DRMS Inspection Report, March 29, 2024 Inspection, Lorencito Canyon, C-1996-084

PERMIT INFORMATION

Permit Number: C-1996-084 Mine Name: Lorencito Canyon Mine Operator: New Elk Coal Company, LLC Operator Address: Mr. John Terry 12250 Highway 12 Weston, CO 81091 County: Las Animas Operation Type: Surface Permit Status: Permanent Cessation Ownership: Private

Figure 1. Areas where rills, gullies and sparse vegetation has been found to be a persistent problem at the site are within the dotted circle areas. Background image is the 2020 annual report map.

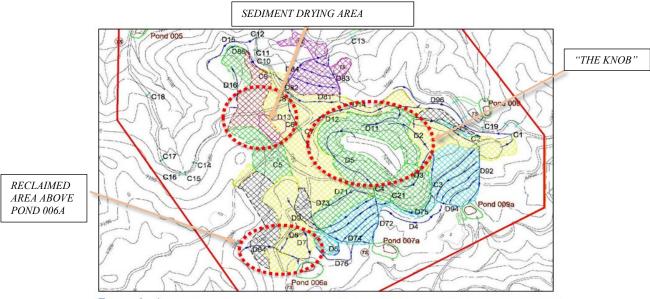
- 4. The following items pertain to ongoing erosional issues in the areas shown in Figure 1, that pursuant to Rule 4.14.6 need to be addressed. A Technical Revision will be required to expand on the current Rill and Gully plan in the PAP. The Operator shall submit the technical revision, obtain approval, repair the erosion, and stabilize the slopes pursuant to the approved plan by December 31, 2024.
